BUILDING PERMIT REPORT

DATE: 16 June 2000 ADDRESS: Island Ave. C.I. CBL: 109C-A-048

REASON FOR PERMIT: Single Family Dwelling

**CITY OF PORTLAND, ME
BOCA 1999 Plan Review Record
One and Two Family Dwelling**

Lodge East Elevation

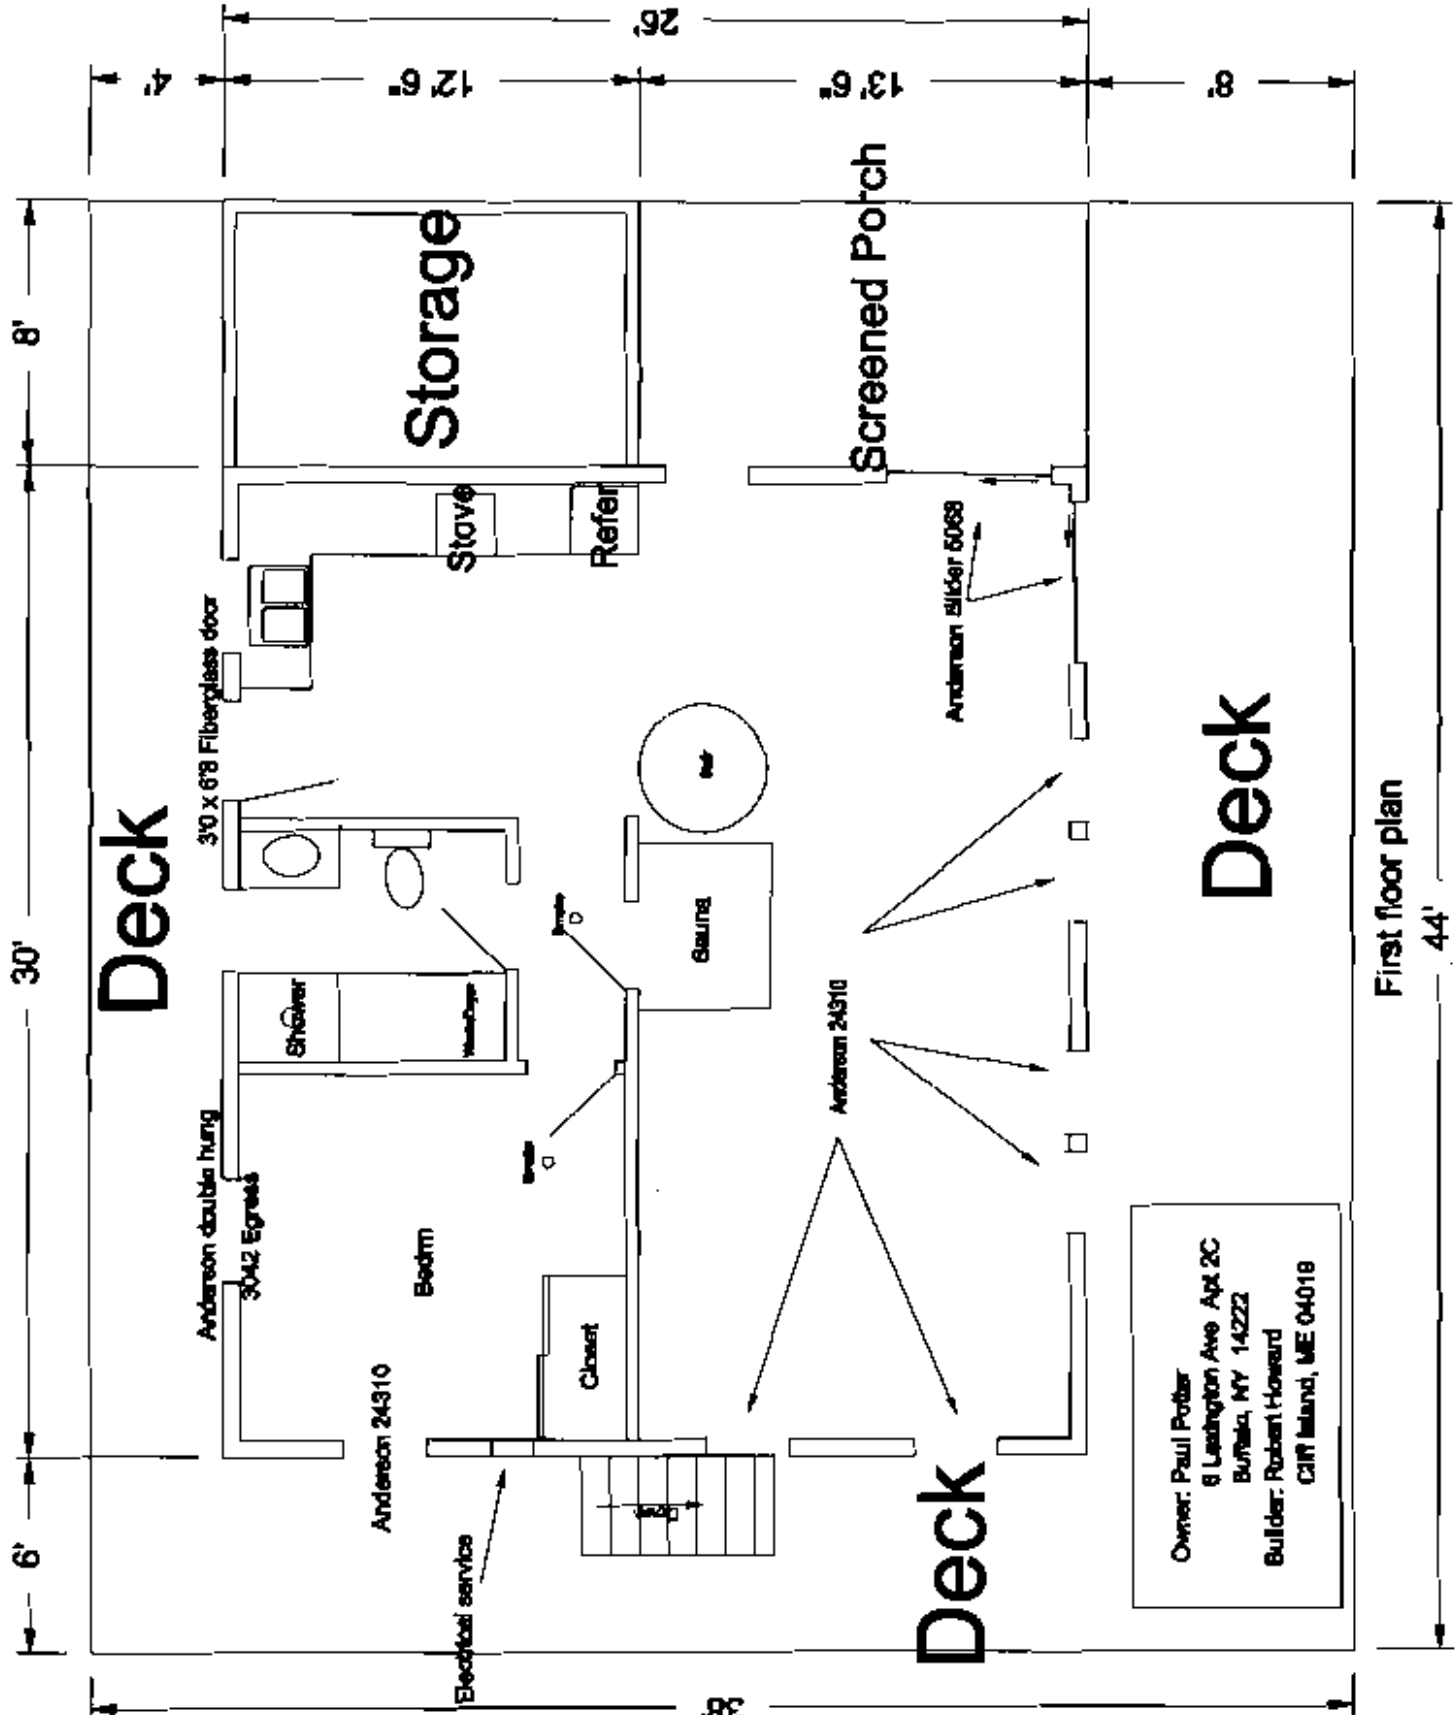
SKY LIGHTS
SECTION 2405

Section 1
Glass
sec. 2406.p

STAIR COMB
sec. 10140

Handrails sec. 1021.p

Fastening
devices

Handrails
sec. 1021.p

ALL
PARTS
BRACED

South Elevation

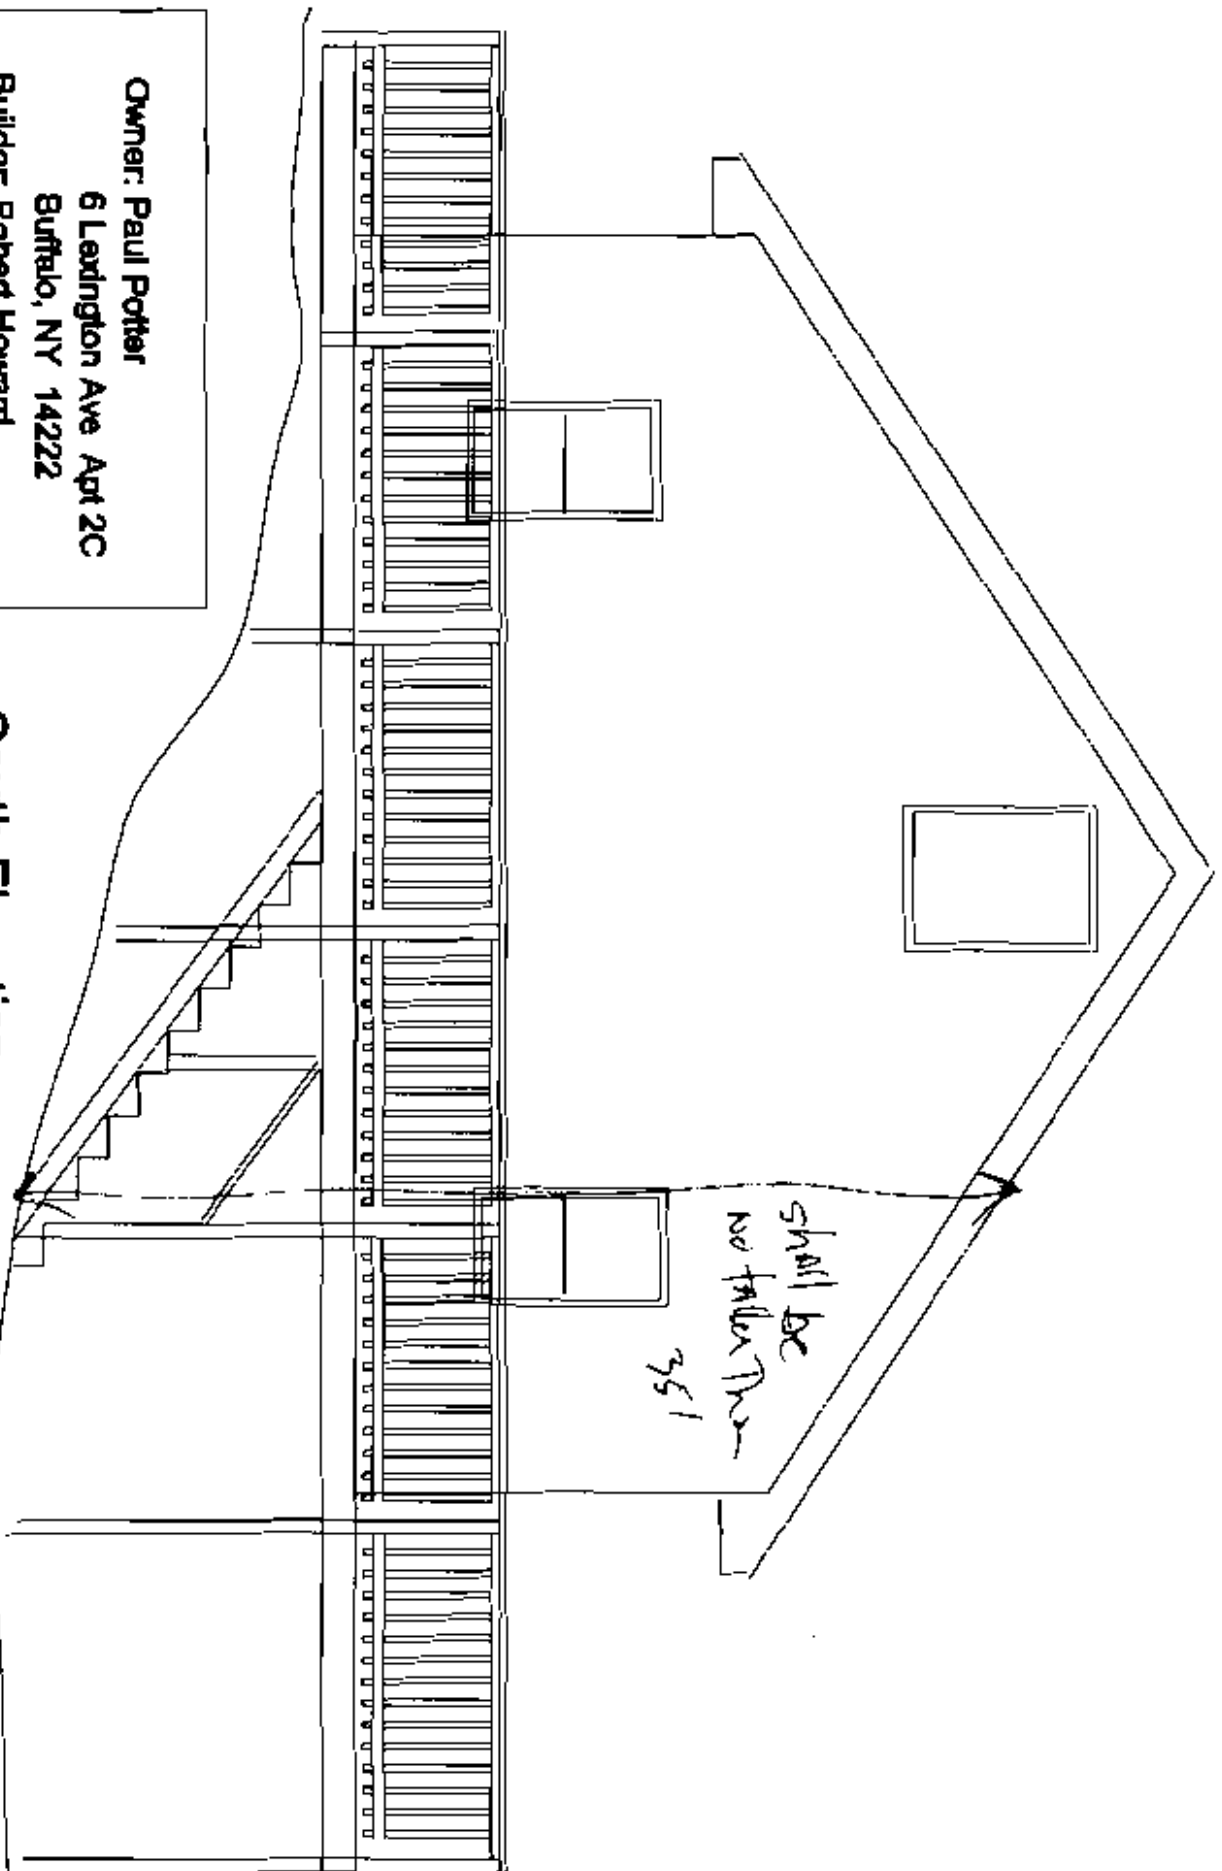
shall be
no taller than
35'
